State of Hawaii
DEPARTMENT OF LAND AND NATURAL RESOURCES
ENGINEERING DIVISION
1151 Punchbowl Street, Room 221
Honolulu, Hawaii 96813

ADDENDUM NO. 2

Job No. F48C612A
Keaiwa Heiau State Recreation Area Water System Improvements
Aiea, Hawaii

May 19, 2026

DESIGNED: SAK	DRAWING NO. C-8
DRAWN: RIT	
CHECKED: SAK	
APPROVED: <i>[Signature]</i>	DATE: May 19, 2026
CHIEF ENGINEER

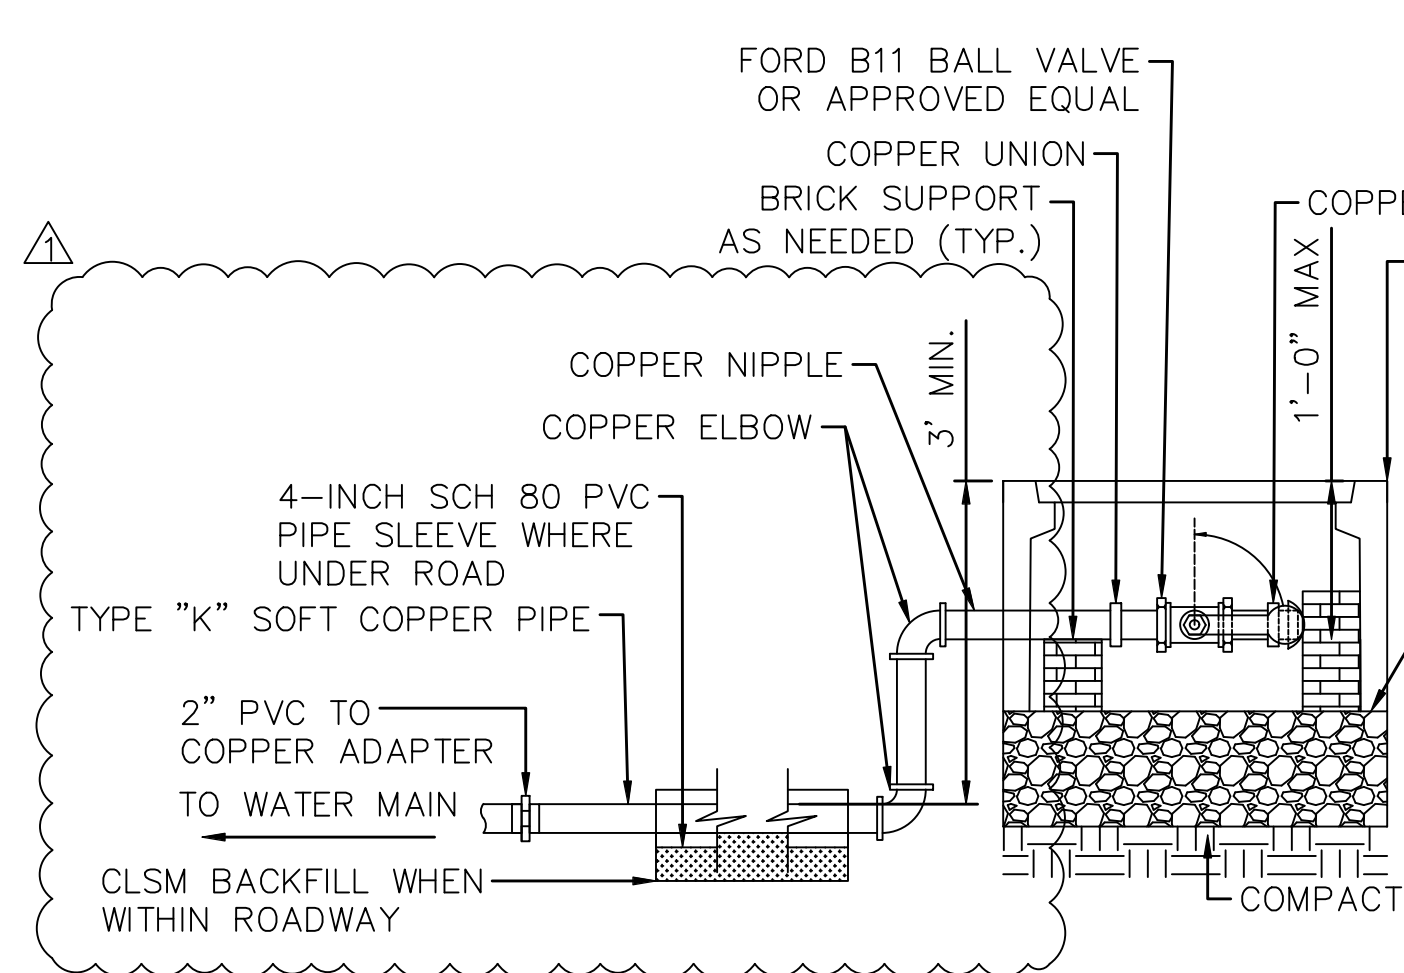
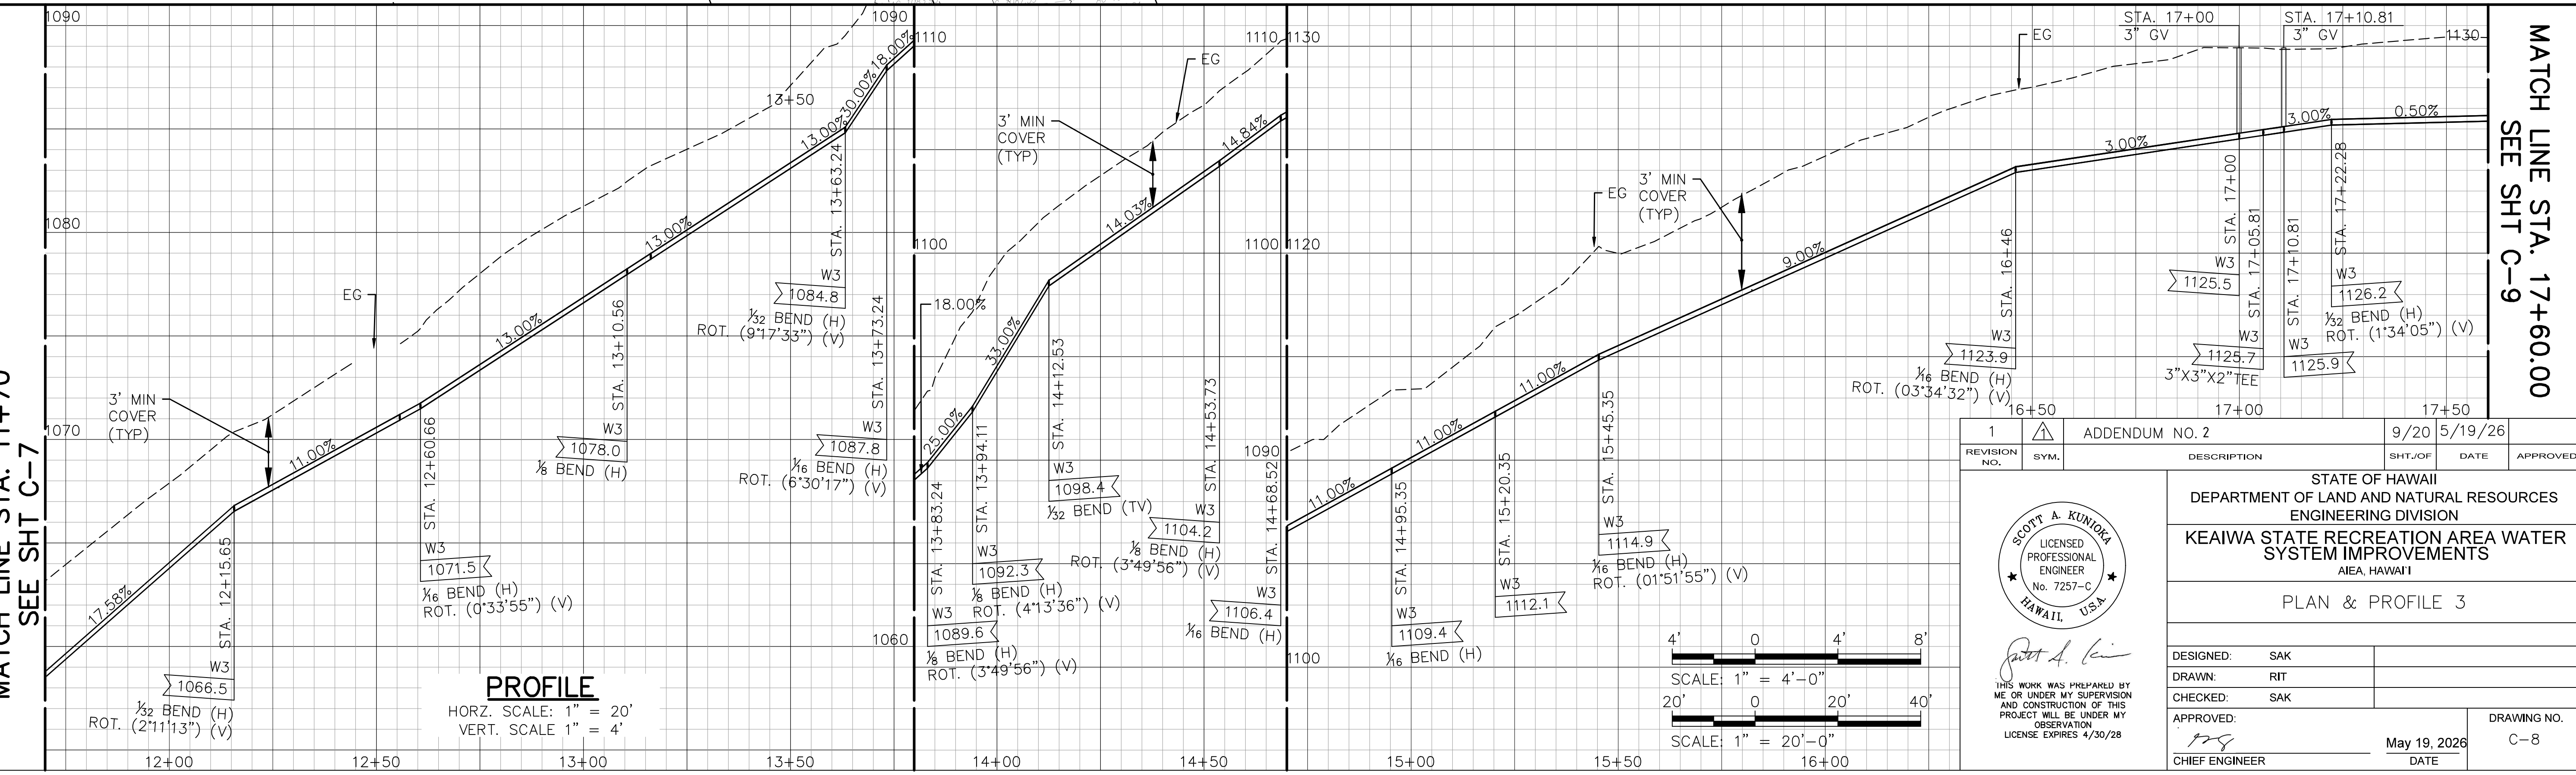
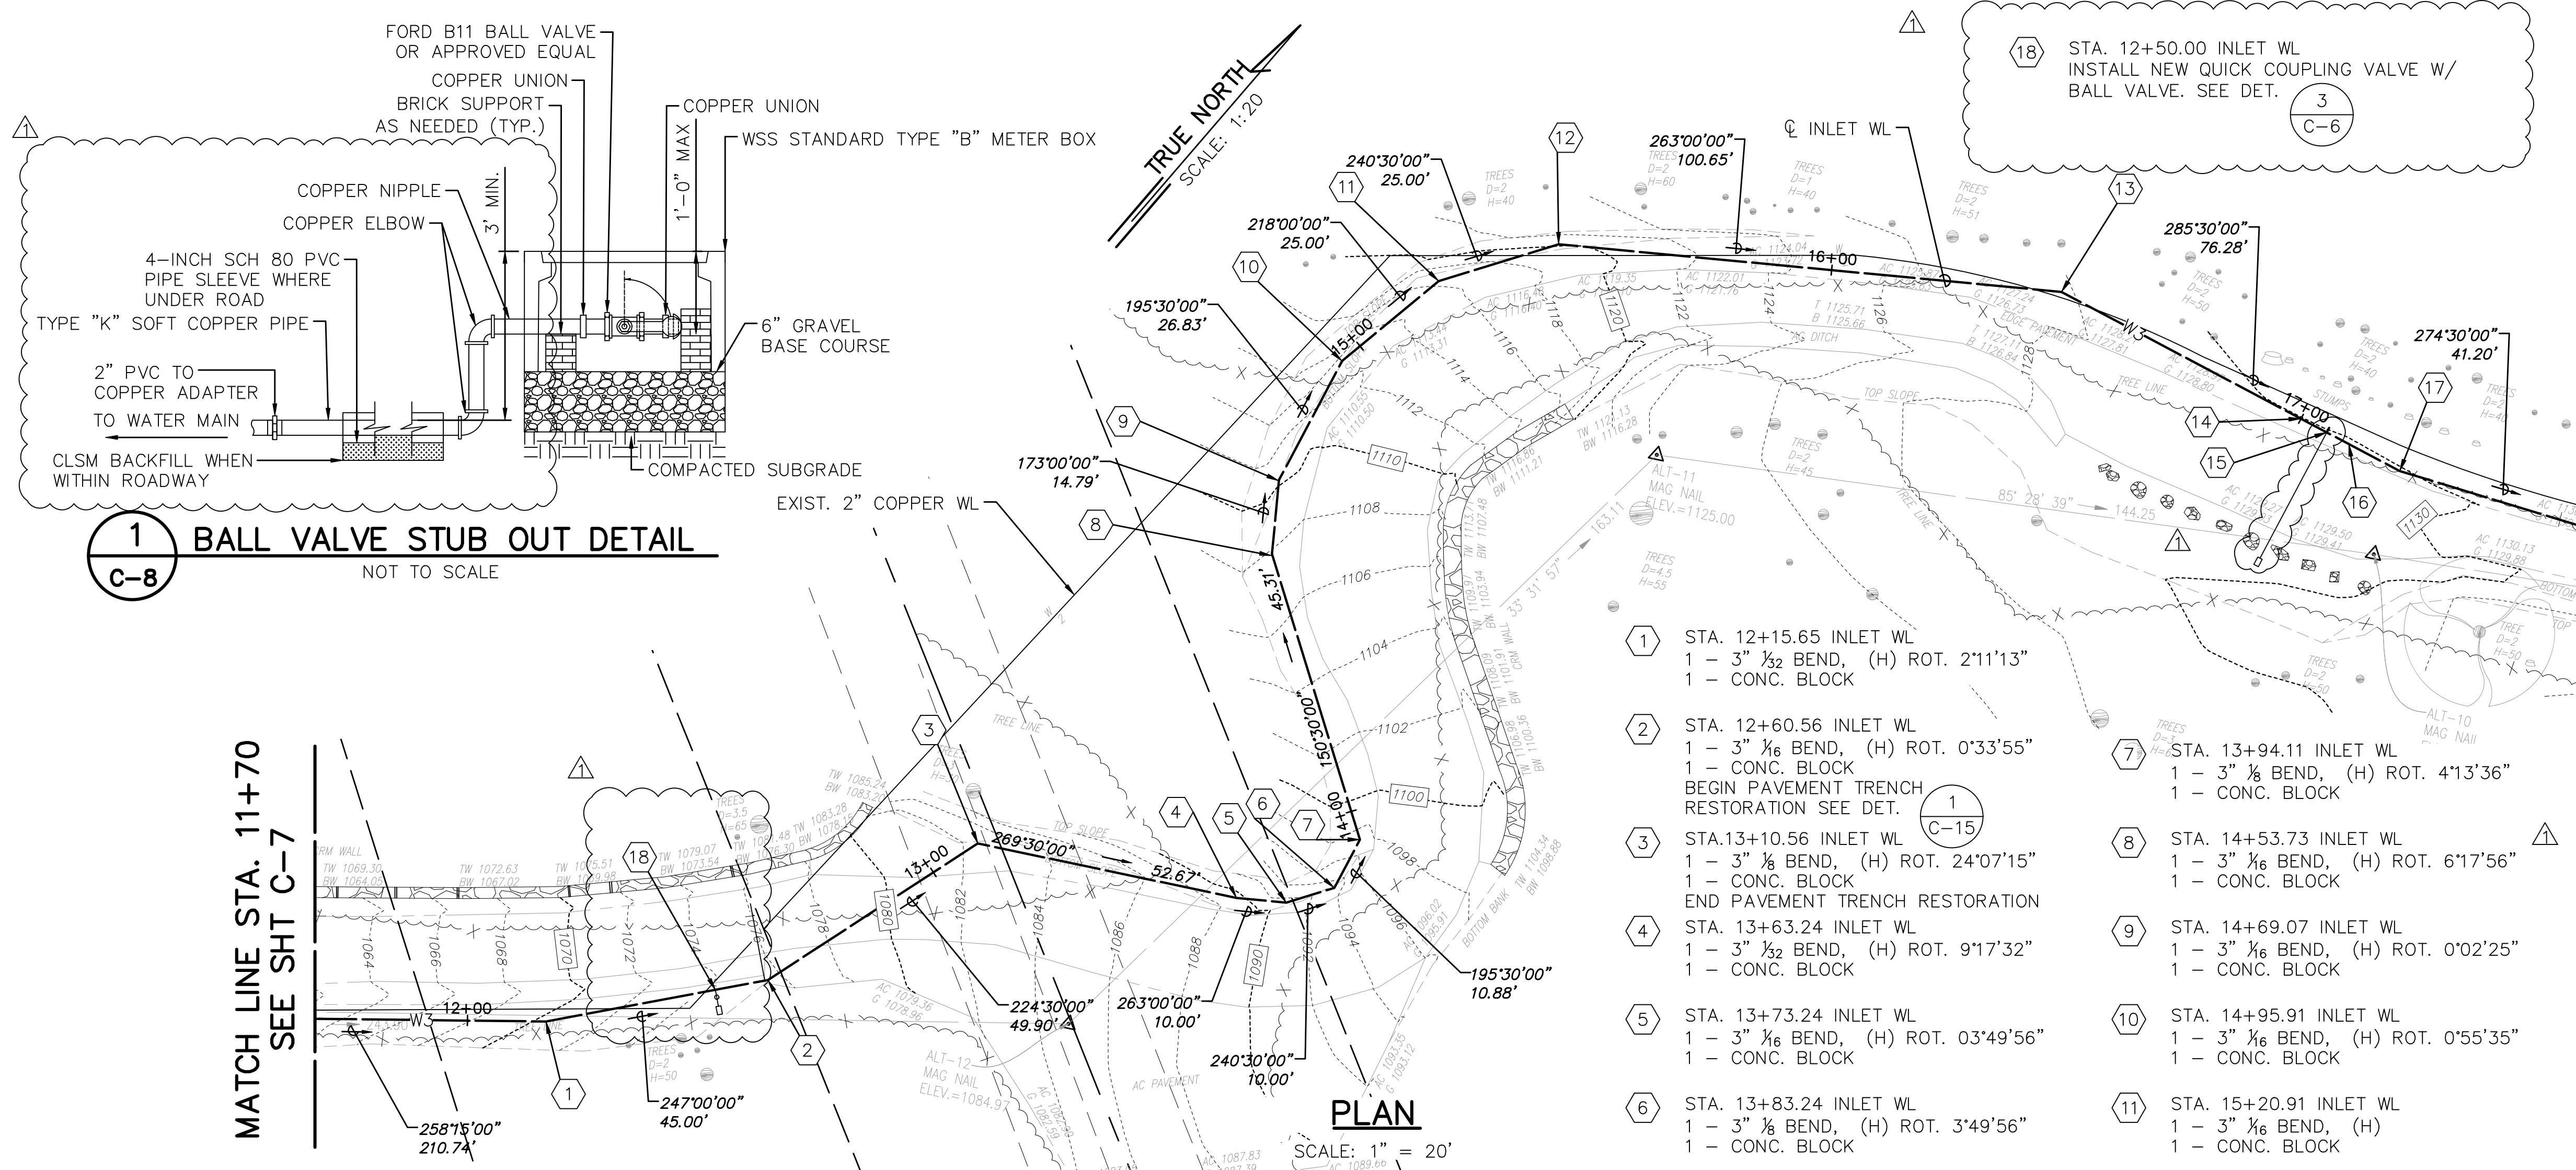
4. Sheet C-8 – Plan & Profile 3, Replace sheet with the attached revised Sheet C-8.
 - a. Added new quick coupling valve.
 - b. Revised pipe stub out.
 - c. Added detail.

1 BALL VALVE STUB OUT DETAIL
C-8 NOT TO SCALE

- ⑮ STA. 17+05.81 INLET WL
1 - 3"X3"X2" TEE
28 LF - TYPE "K" SOFT COPPER PIPE
20 LF - SCH 80 PVC 4"
INSTALL BALL VALVE STUB OUT DETAIL THIS SHT.
- ⑯ STA. 17+10.81 INLET WL
1 - 3" GV SEE DET. ③ C-16

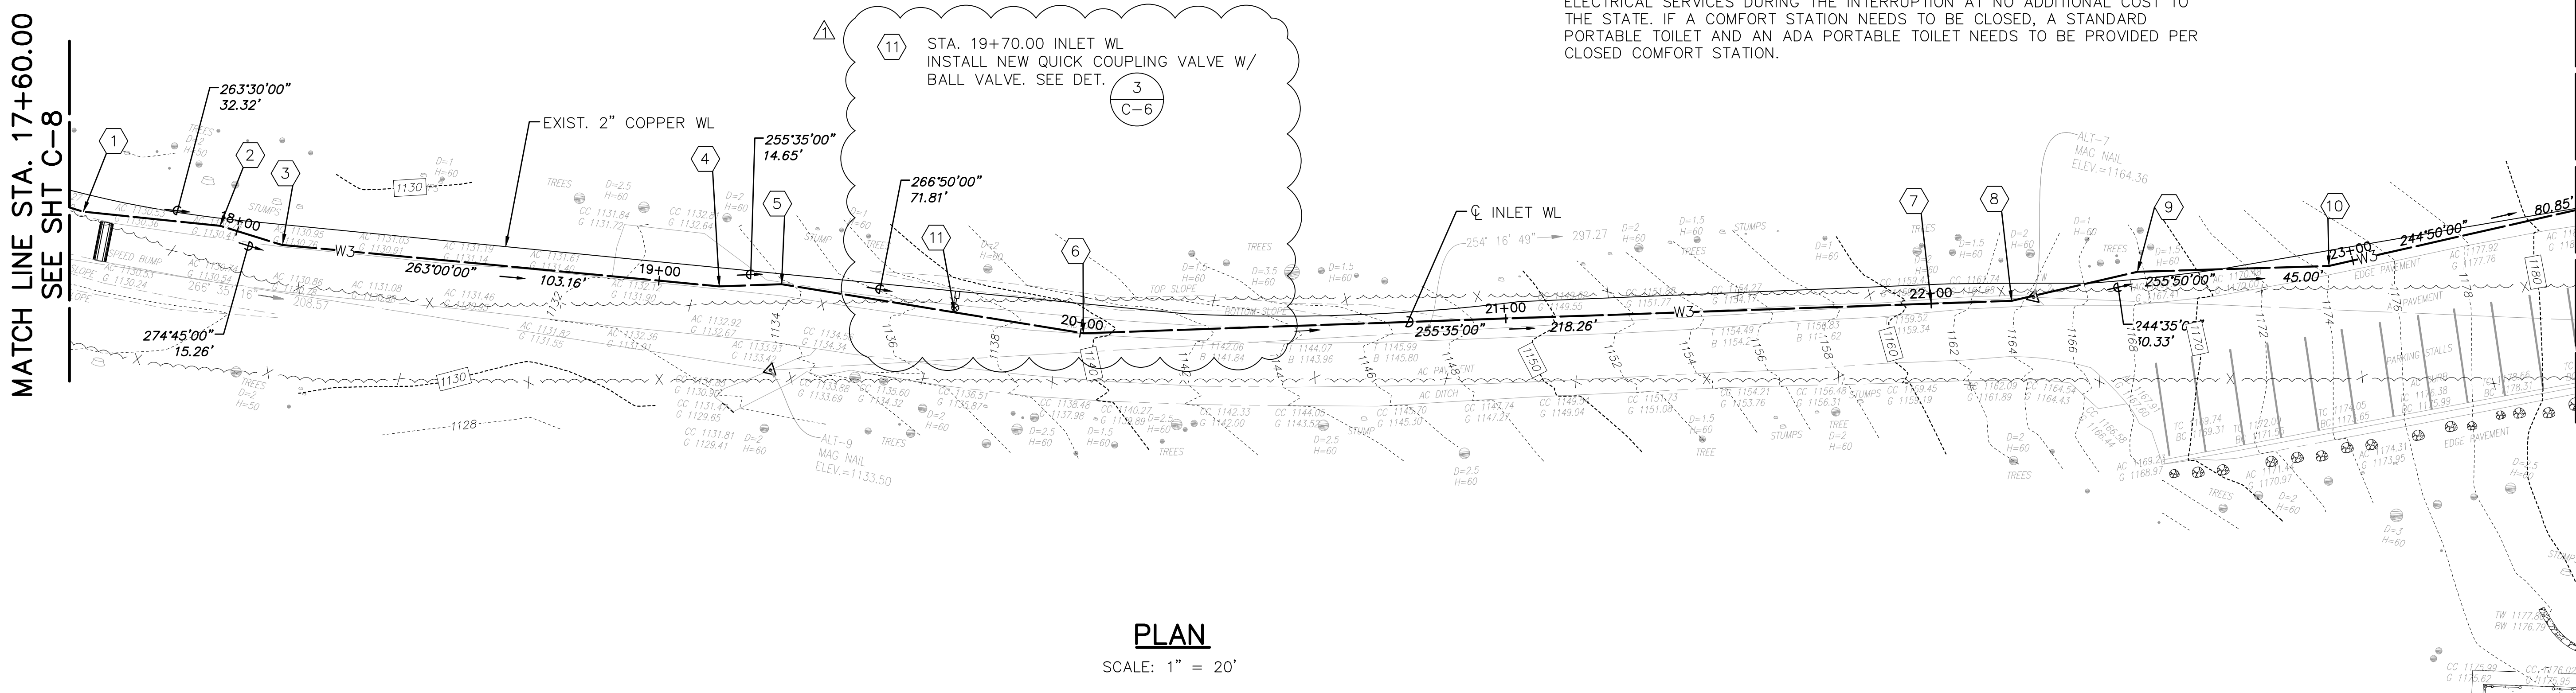
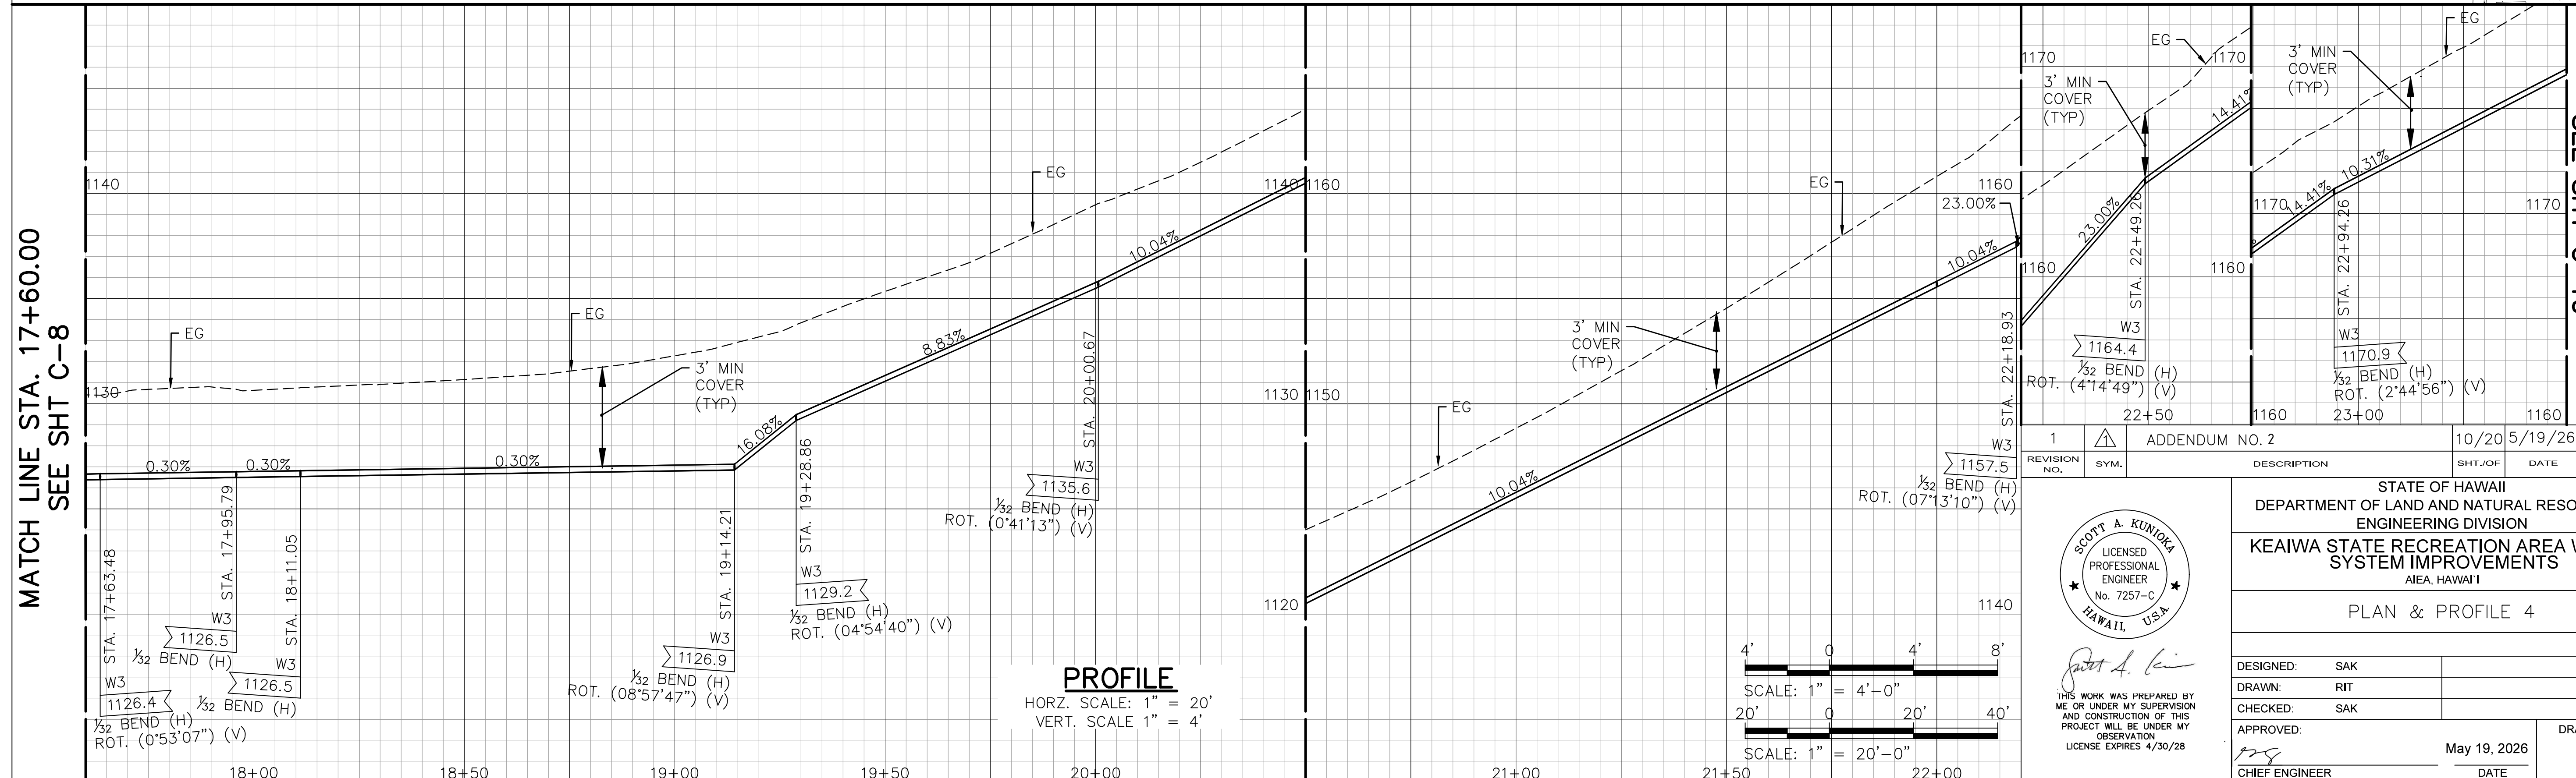
5. Sheet C-9 – Plan & Profile 4, Replace sheet with the attached revised Sheet C-9.
 - a. Added new quick coupling valve.
6. Sheet C-10 – Plan & Profile 5, Replace sheet with the attached revised Sheet C-10.

- ① STA. 17+63.48 INLET WL
1 - 3" 1/2 BEND, (H) ROT. 0°53'07"
1 - CONC. BLOCK
- ② STA. 17+95.79 INLET WL
1 - 3" 1/2 BEND, (H)
1 - CONC. BLOCK
- ③ STA. 18+11.05 INLET WL
1 - 3" 1/2 BEND, (H)
1 - CONC. BLOCK
- ④ STA. 19+14.21 INLET WL
1 - 3" 1/2 BEND, (H) ROT. 08°57'47"
1 - CONC. BLOCK
- ⑤ STA. 19+28.86 INLET WL
1 - 3" 1/2 BEND, (H) ROT. 04°54'40"
1 - CONC. BLOCK
- ⑥ STA. 20+00.67 INLET WL
1 - 3" 1/2 BEND, (H) ROT. 0°41'13"
1 - CONC. BLOCK
- ⑦ STA. 21+18.93 INLET WL
1 - 3" 1/2 BEND, (H) ROT. 07°13'10"
1 - CONC. BLOCK
- ⑧ STA. 22+18.93 INLET WL
1 - 3" 1/2 BEND, (H) ROT. 07°13'10"
1 - CONC. BLOCK
- ⑨ STA. 22+49.26 INLET WL
1 - 3" 1/2 BEND, (H) ROT. 04°14'49"
1 - CONC. BLOCK
- ⑩ STA. 22+94.26 INLET WL
1 - 3" 1/2 BEND, (H) ROT. 02°44'56"
1 - CONC. BLOCK
- ⑪ STA. 19+70.00 INLET WL
INSTALL NEW QUICK COUPLING VALVE W/
BALL VALVE. SEE DET.
